RE: Response to EPA Letter dated March 25, 2009
The Sherwin-Williams Company (February 18, 2009) Response to EPA Letter dated January 14, 2009 EPA's Comments on the *"Revised" Route 561 Dump Site Ground Water Contour Maps* (dated August 29, 2008)

The Sherwin-Williams Company Sites – RI/FS Activities
Gibbsboro, New Jersey
Administrative Order Index No. II CERCLA-02-99-2035

TITLE: Dump Site
Proposed Monitoring Well Location Map
(January 14, 2009 EPA Comment Letter)

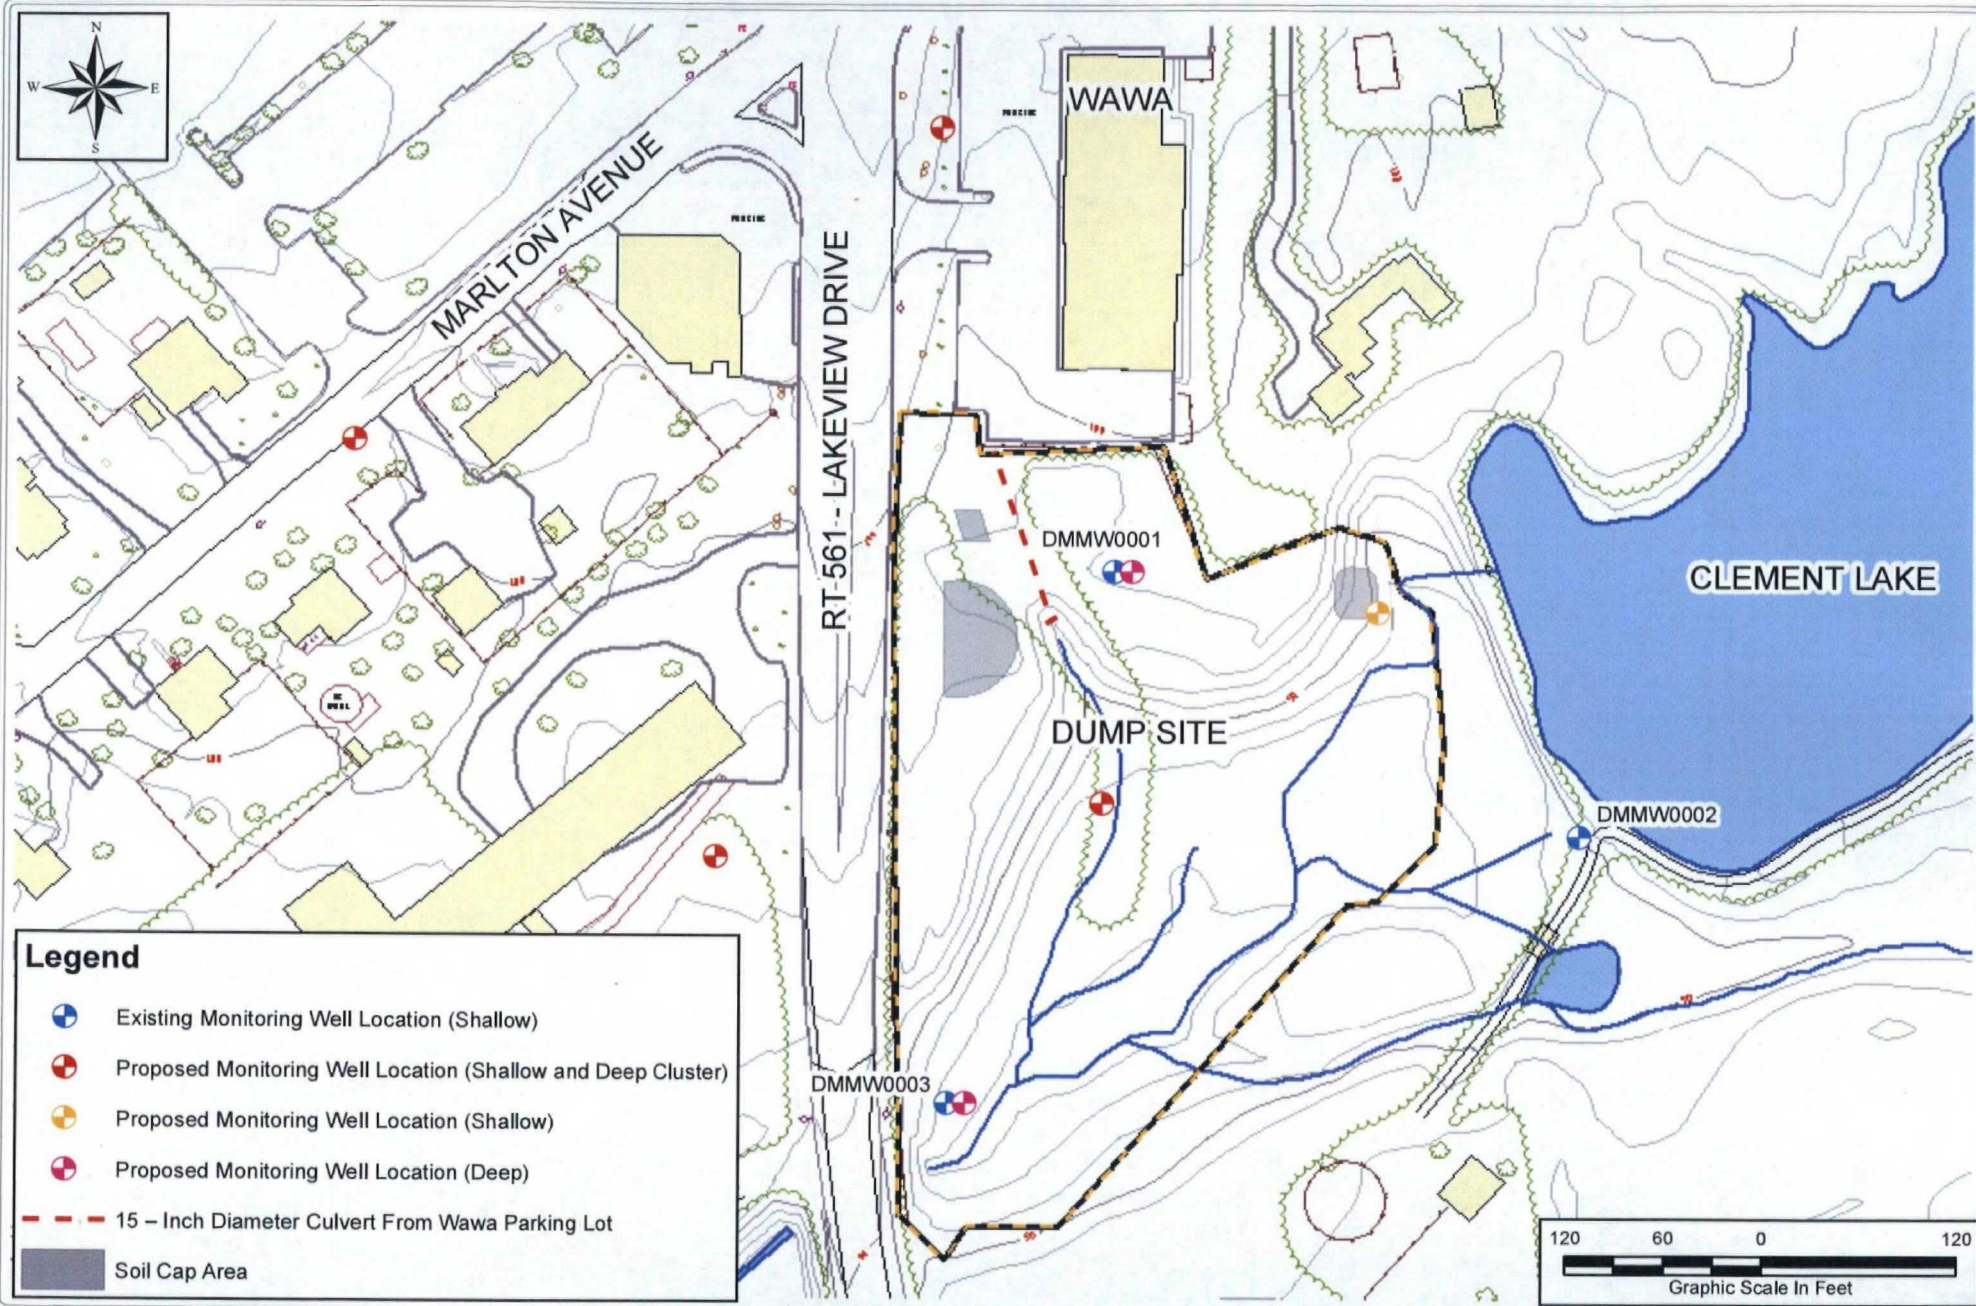
Presently, there are three shallow wells located within the Dump Site fenced area that were installed during the RI activities conducted in July 2005. As discussed during the December 18, 2008 Gibbsboro project meeting, EPA is recommending 11 new wells be installed to supplement the three existing shallow wells.

These 11 wells are comprised of four well couplets, two deep wells and one shallow well. The four well couplets are proposed at three off-site locations in addition to one location within the Dump Site. The two deep wells are intended to be co-located at existing shallow well locations (DMMW0001 and 0003) to form couplets. There is one shallow well proposed within the fenced area near the northeastern fence line adjacent to Clement Lake. These locations are presented on the attached Figure 1.

Dump Site
Revised Proposed Monitoring Well Location Map
With Pore Water Locations
(March 25, 2009 EPA Comment Letter)

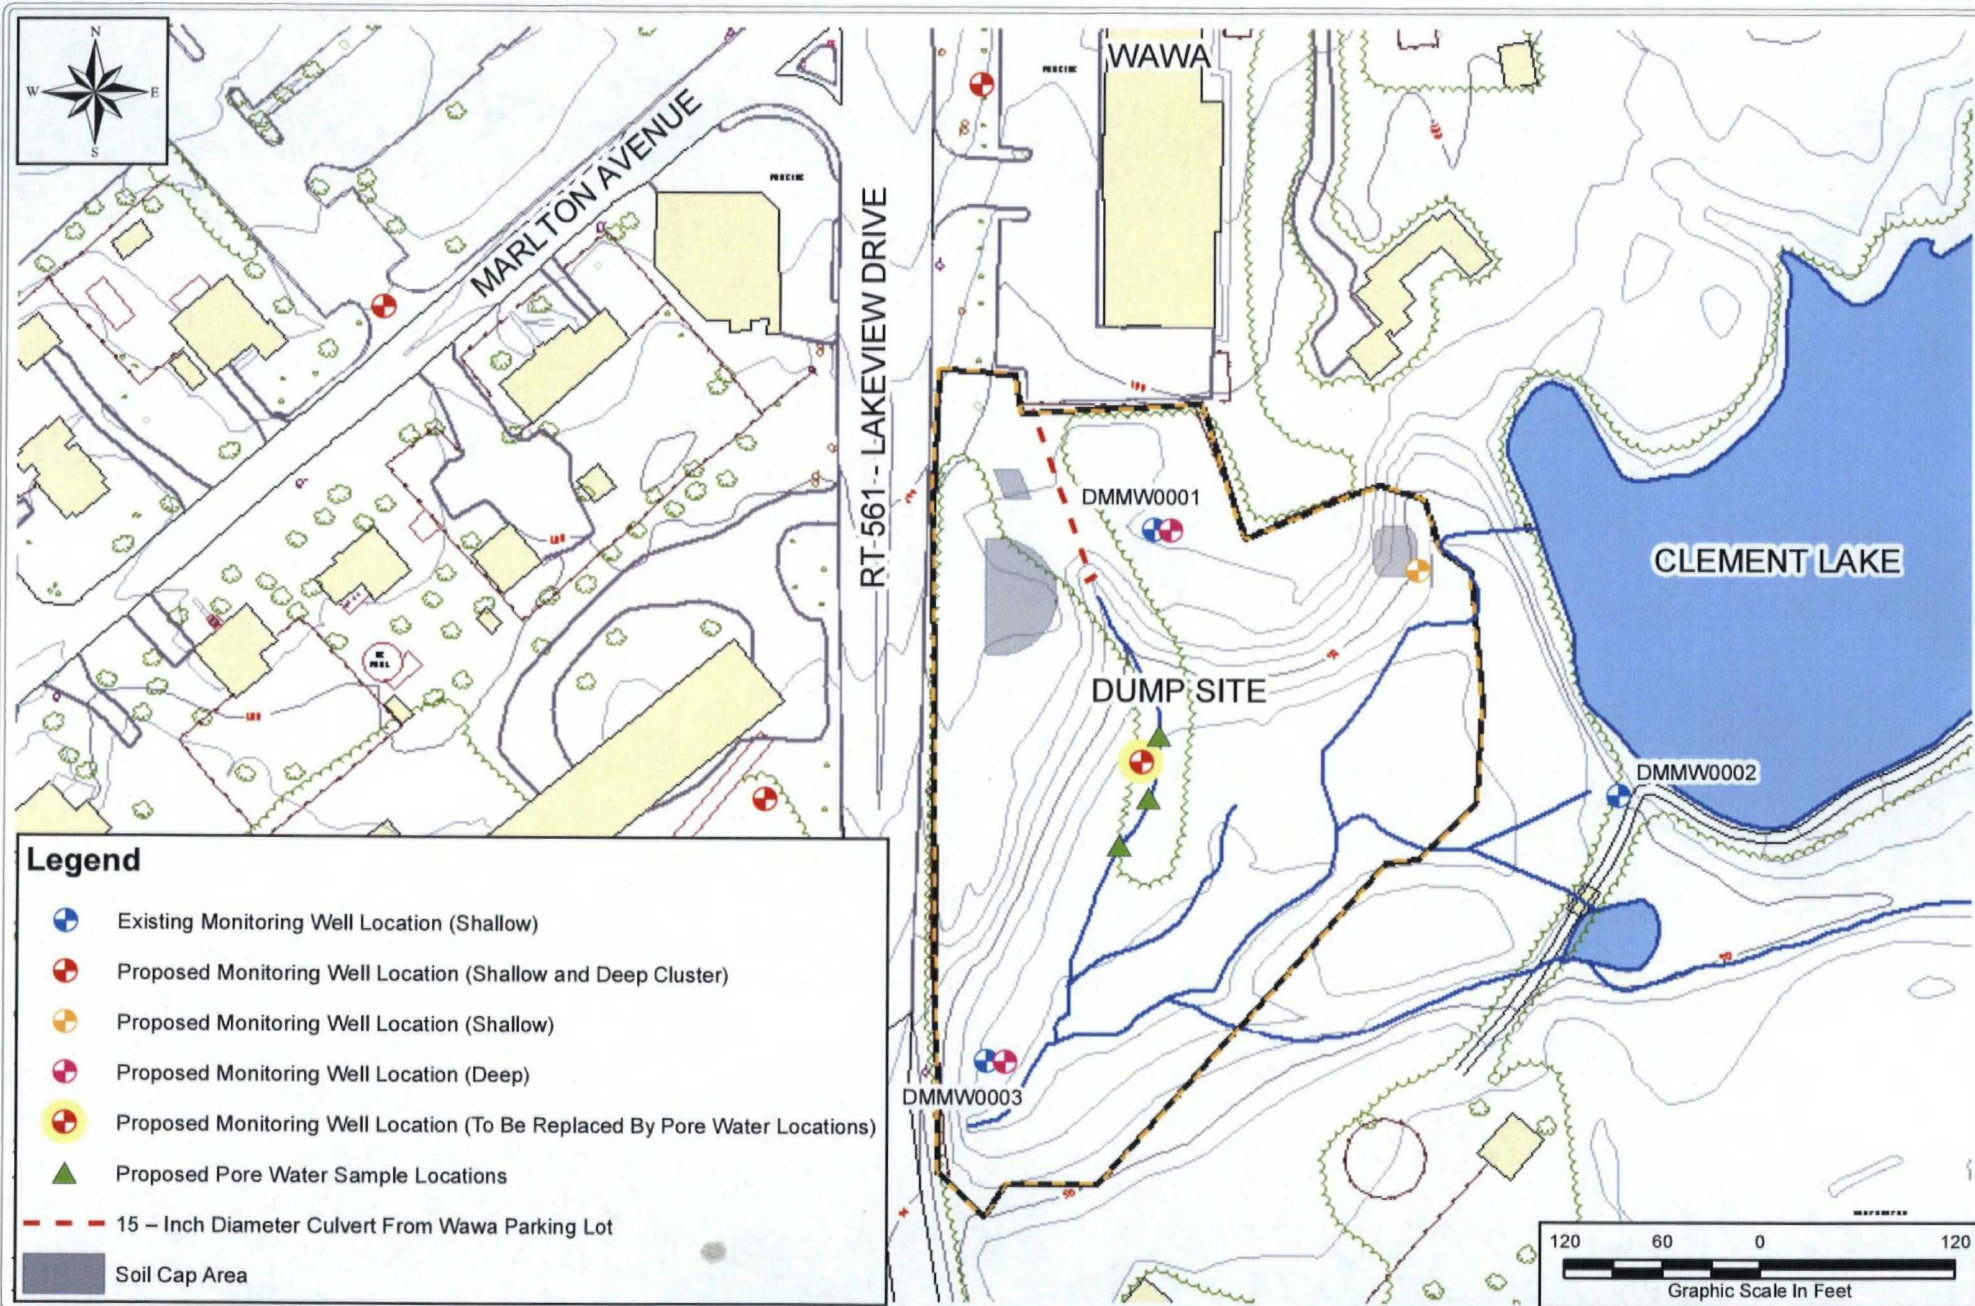
On March 25, 2009, Ray Klimcsak (EPA) along with Patrick Austin and Arthur Fischer (both Weston Solutions, Inc. [Weston®]) inspected the proposed locations that Weston and the drilling subcontractor (ECDI) marked out the previous week. Due to accessibility issues, there were three locations identified that would require the proposed monitor well locations to be shifted. They are as follows:

- Due to the proximity of underground and overhead utilities, it is suggested that the proposed well cluster on Marlton Avenue be shifted approximately 30 feet from the south side of the street to the north side of the street.
- Due to the proximity of a large tree, the proposed well cluster next to the Medical Arts Building (across Route 561 from the Dump Site) will need to be shifted approximately 10 to 20 feet in a northeasterly direction towards Route 561.
- Due to its location in an inaccessible area of the wetlands (soft, wet soils), it is suggested that the proposed well cluster in the middle of the site (near the base of the slope where the culvert from the Wawa parking lot runs) be shifted upslope approximately 50 feet to a more accessible, stable area.

As a result of this site walk, EPA concurred with the re-location of the well clusters located on Marlton Avenue and next to the Medical Arts Building. However, in lieu of the monitoring well cluster in the middle of the site (near the intermittent stream), EPA is requesting that three or four pore water samples be collected along the intermittent stream. These revised monitor well and pore water locations are presented on the attached Figure 2.
